Memorandum

CITY OF DALLAS

SUBJECT **Southern Gateway Ramp Design Modifications**

**MODIFICATIONS
PROPOSED FOR A
SECTION OF THE
I-35E/US 67 PROJECT
AT I-35E NORTHBOUND
EXIT TO 8TH STREET**

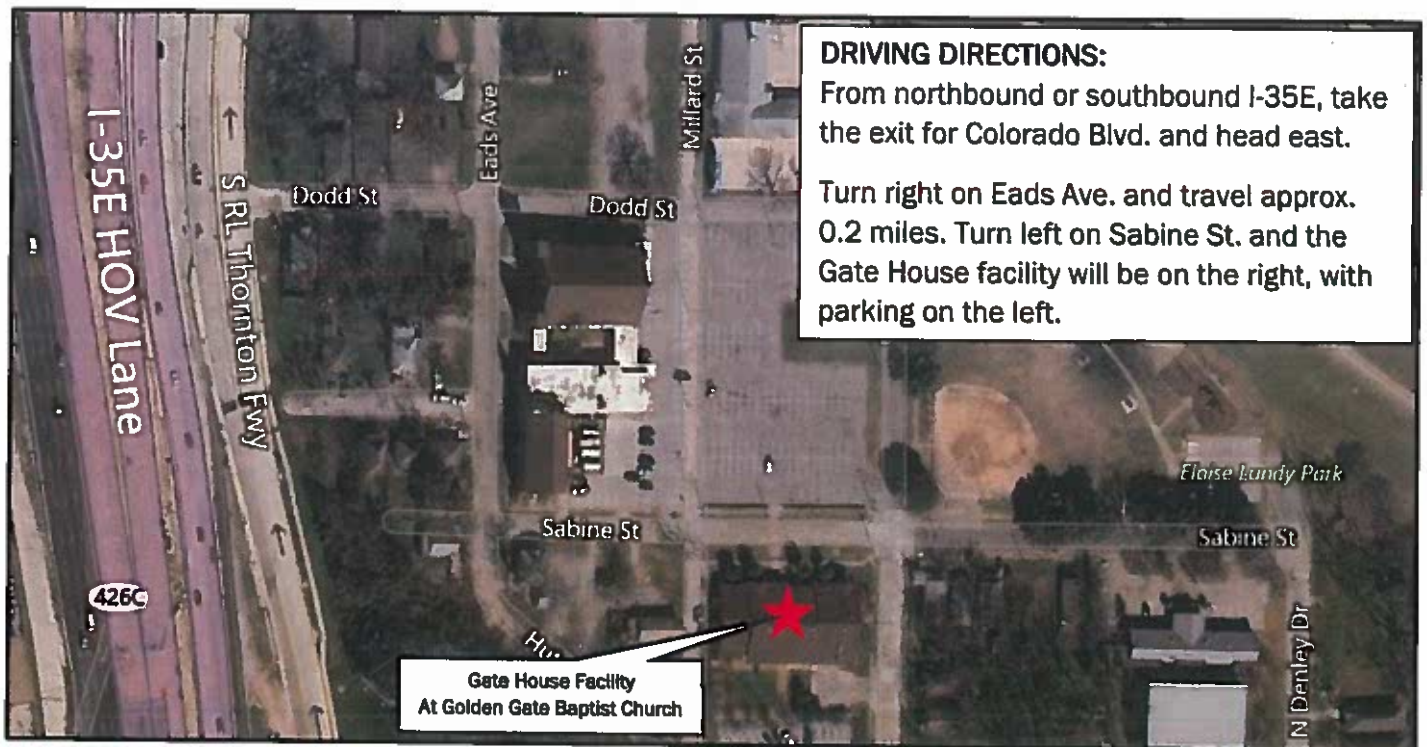
The first design modification would move the 10th Street off-ramp further to the west. The previous design configuration provided a shorter weaving distance for northbound IH 35E traffic exiting to 8th Street. The revised design creates safer pedestrian access for the intersection at the IH 35E northbound frontage road.

Off ramp connection to 10th Street

**MODIFICATIONS PROPOSED
FOR A SECTION OF THE
I-35E/US 67 PROJECT AT
LOOP 12**

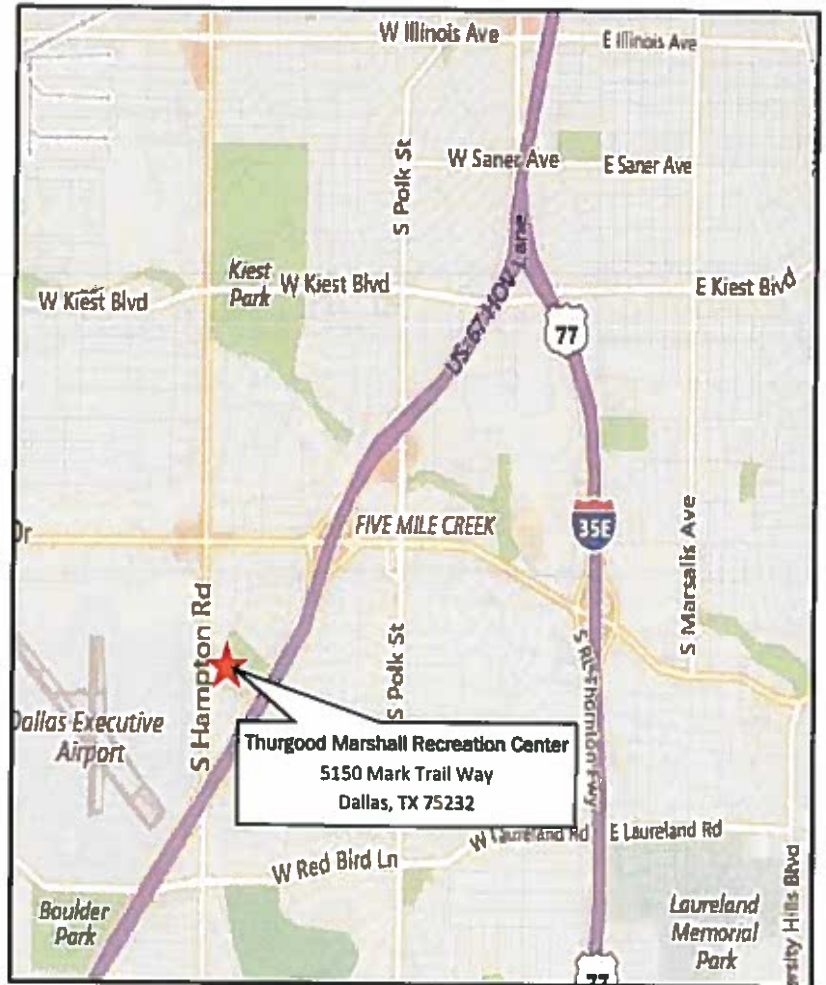
The second design modification would eliminate the cloverleaf ramps at Loop 12 in favor of a conventional diamond ramp configuration. Converting to a traditional diamond intersection improves safety by eliminating weaving movements while maintaining current levels of service for traffic operations.

Removal of all four loop ramps

New on ramp entrance
